HISTORIC AND DESIGN REVIEW COMMISSION

October 05, 2022

HDRC CASE NO: 2022-452
ADDRESS: 223 E CAROLINA ST
LEGAL DESCRIPTION: NCB 3010 BLK 8 LOT 15
ZONING: RM-4, H
CITY COUNCIL DIST.: 1
DISTRICT: Lavaca Historic District
APPLICANT: Alan Yoshida
OWNER: Alan Yoshida
TYPE OF WORK: Post-work approval of demolition of accessory, construction of a carport with shipping container, construction of a detached two-story accessory
APPLICATION RECEIVED: August 22, 2022
60-DAY REVIEW: Not applicable due to City Council Emergency Orders
CASE MANAGER: Jessica Anderson
REQUEST:

1. Demolish a rear detached one-story two-bay rear garage.
2. Construct a metal and wood carport with metal shipping container.
3. Construct a rear two-story accessory building.

REVSD:

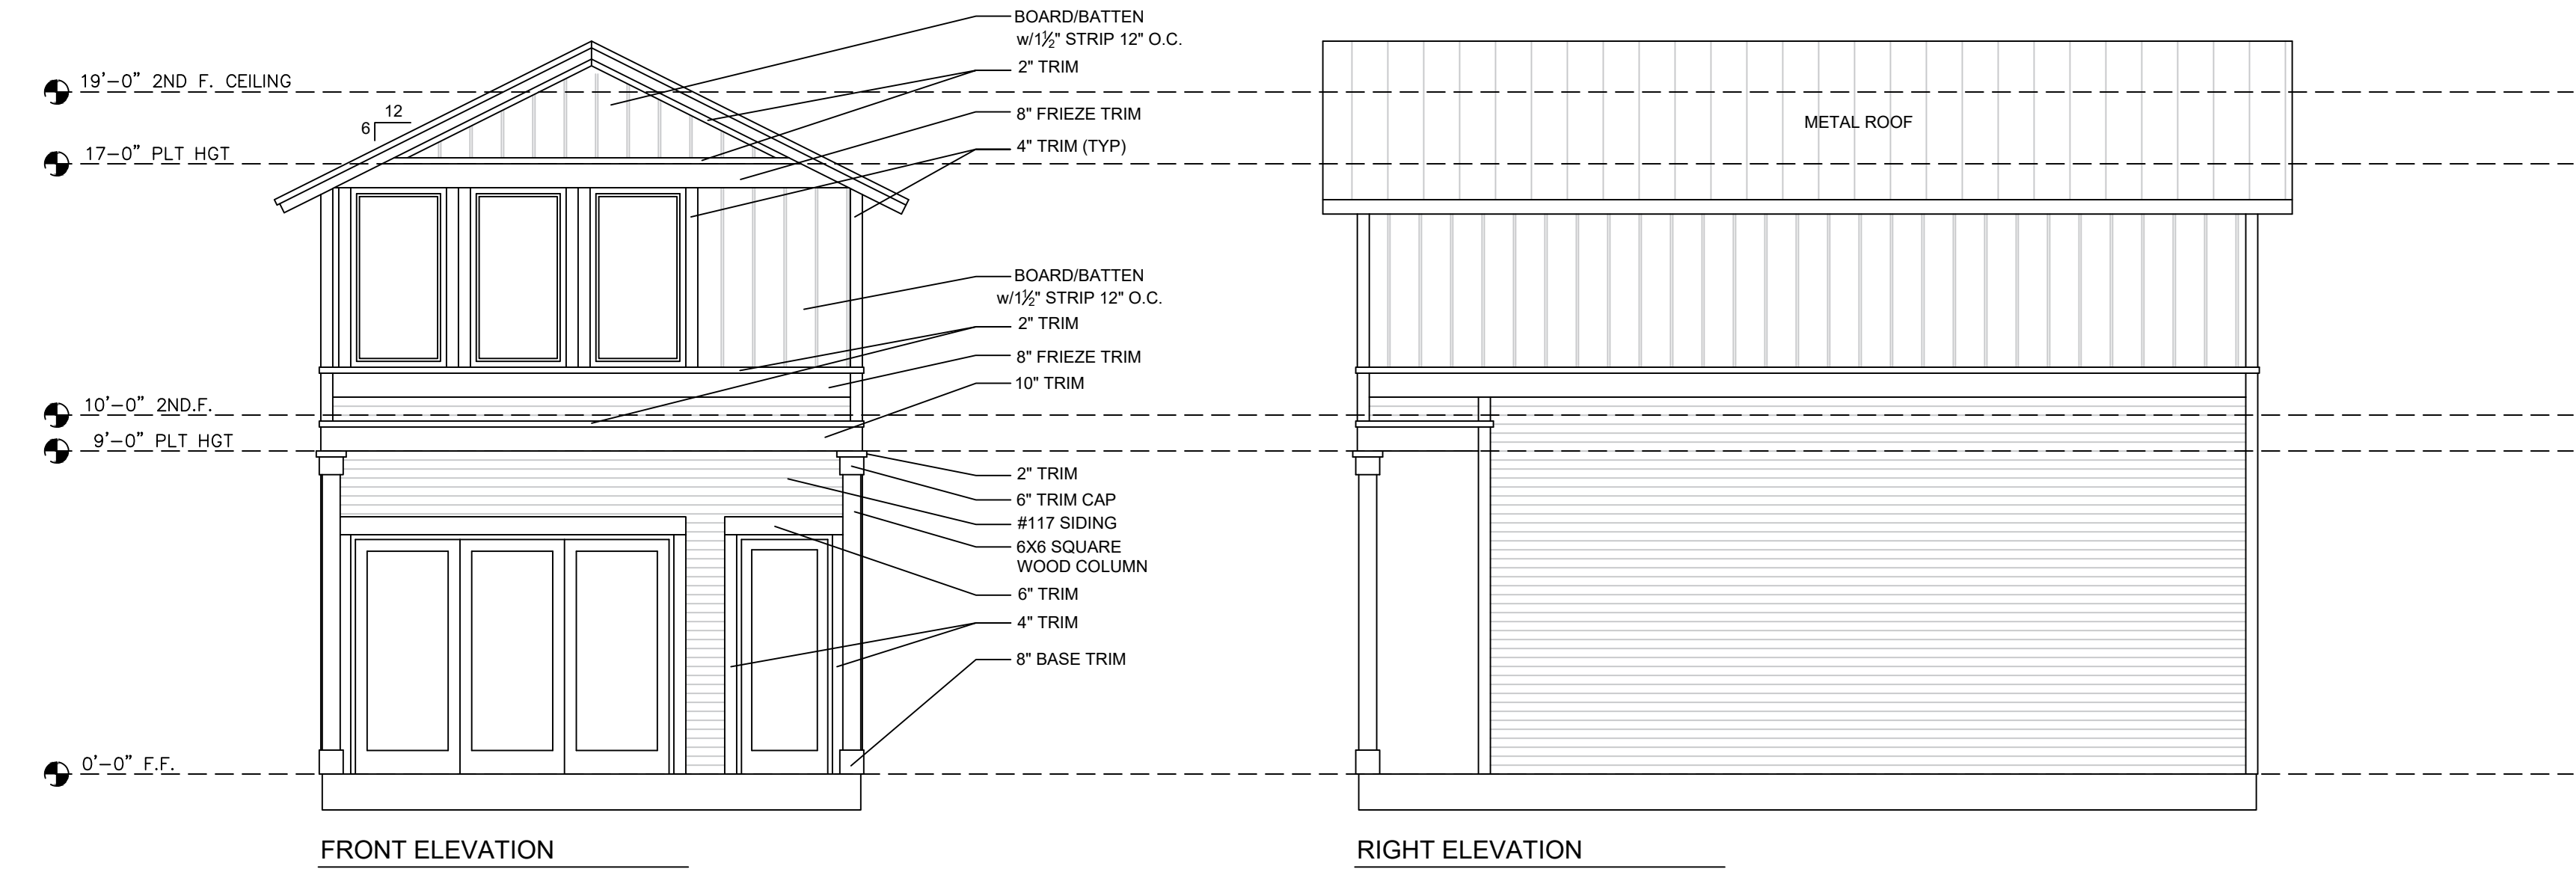
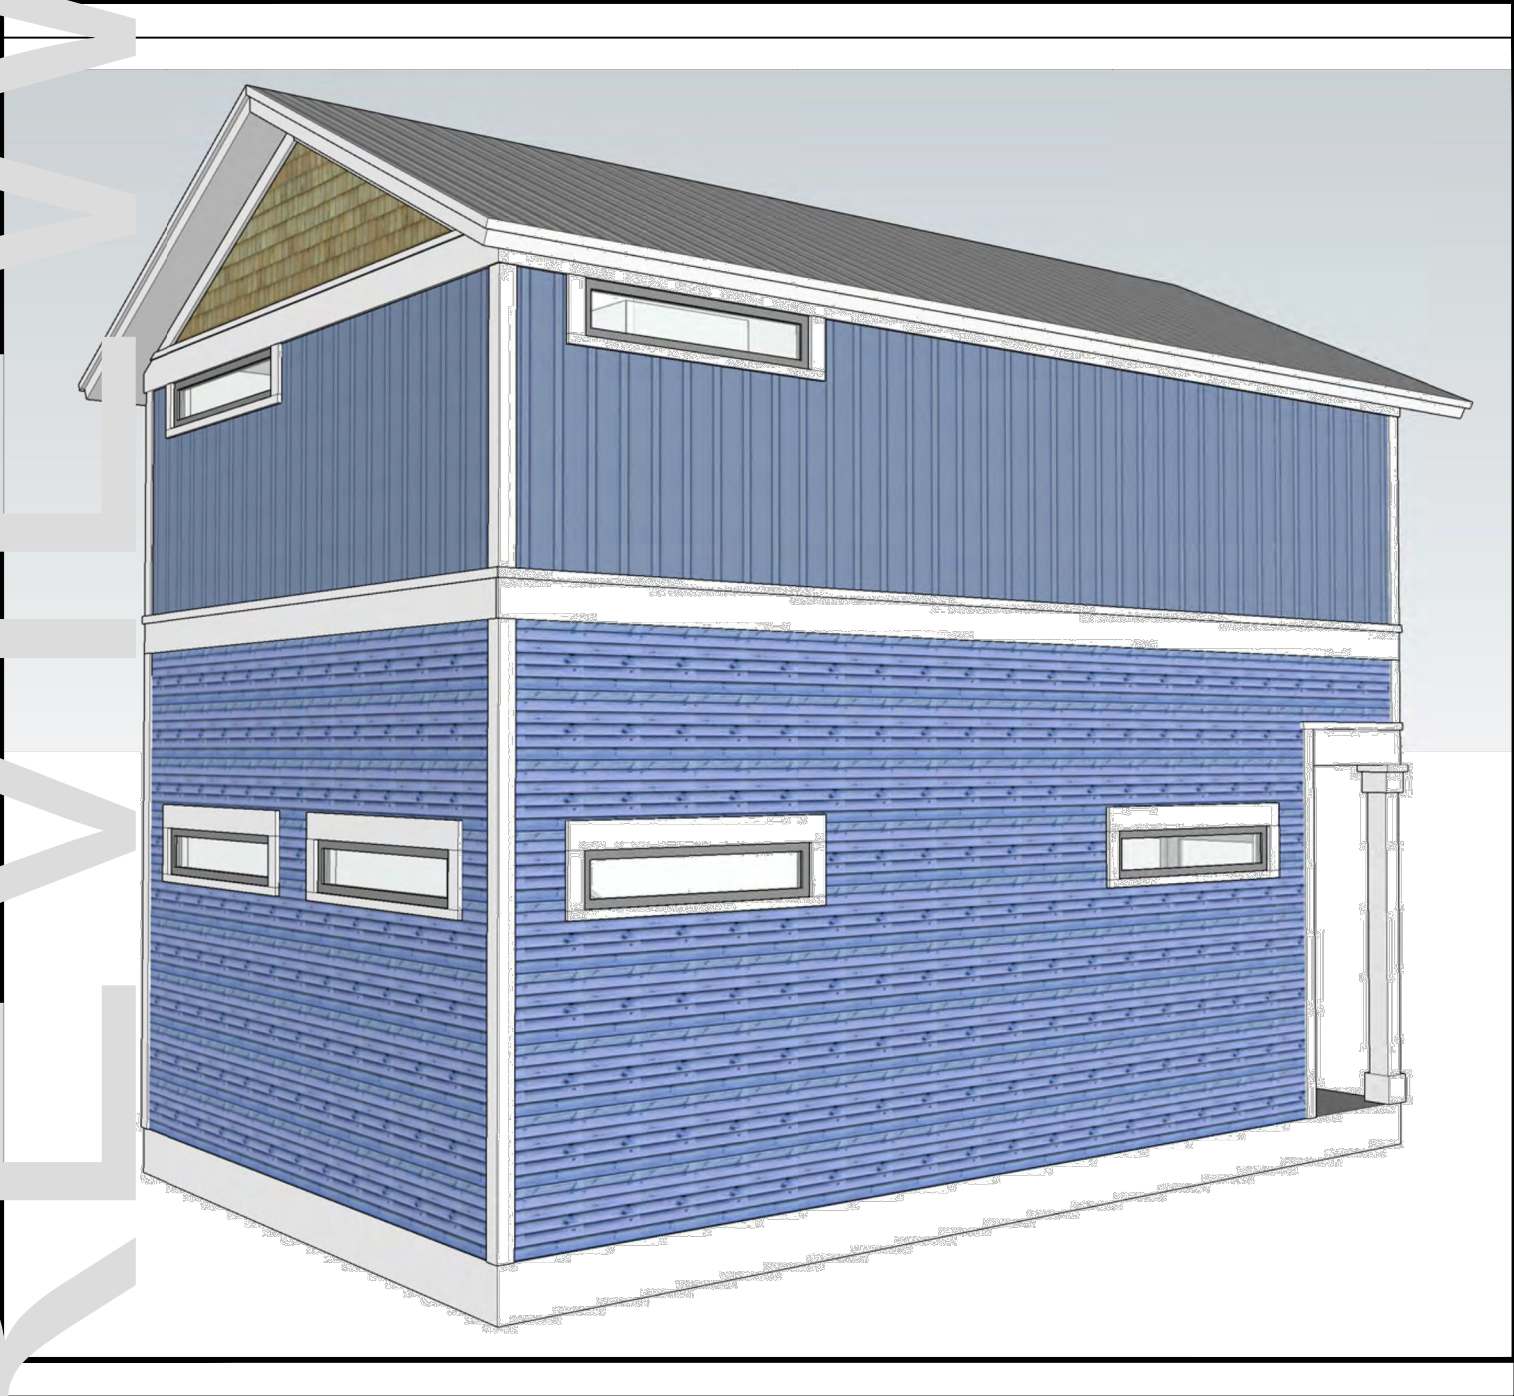
- k. **NEW CONSTRUCTION OF ACCESSORY STRUCTURE:** The applicant requests approval to construct a rear two-story accessory structure. The Guidelines for New Construction 5.A. notes that new garages and outbuildings should be visually subordinate to the primary historic structure in terms of their height, massing, and form, and should be no larger in plan than forty percent of the primary historic structure’s footprint. The existing one-story primary structure features a total footprint of 1,398 square feet. The proposed two-story accessory structures feature a total footprint of 346 square feet, or approximately 25% of the primary structure’s footprint. Accessory structures on the block are predominately single story. Staff finds the proposed height and general massing do not conform to historic design guidelines.

- m. **ARCHITECTURAL DETAILS (MATERIALS):** The Guidelines for New Construction 5.A.iii. and iv. note that new accessory structures should relate to the period of construction of the primary historic structure on the lot through the use of complementary materials and simplified architectural details. The primary structure does not feature a continuous sill line, nor is a sill line characteristic of the Folk Victorian style. The presence of the sill line represents a departure from the period of significance of the primary structure and from use of simplified design as outlined in the guidelines. Staff finds the proposed continuous sill line on the accessory structure does not conform to guidelines.

- n. **WINDOWS:** The applicant proposes ganged fixed-pane windows on the south elevation and fixed clerestory windows on the north and west elevations of the proposed rear accessory structure. There is no fenestration proposed on the east elevation. Windows on the primary historic structure are predominately rectangular one-over-one operable wood windows that appear in ganged pairs or individually. Per Standard Specifications for Windows in Additions and New Construction, new windows on additions should relate to the windows of the primary historic structure in terms of materiality and overall appearance. Windows used in new construction should be similar in appearance to those commonly found within the district in terms of size, profile, and configuration. Staff finds the proposed window profiles are not consistent with these specifications.

Staff recommends approval of item 3, construction of a rear two-story accessory building, based on findings k through n, with the following stipulations:

- i. That the applicant proposes window profiles that have more traditional proportions and configurations (one-over-one) and otherwise meet the Standard Specifications for Windows in Additions and New Construction.
- ii. That the applicant incorporate windows on the east elevation of the accessory structure.
- iii. That the applicant submits materials specifications and details for the proposed windows.
- iv. That the applicant remove the continuous sill line from the design.
- v. The applicant is responsible for meeting all setback and building separation requirements per the zoning code.
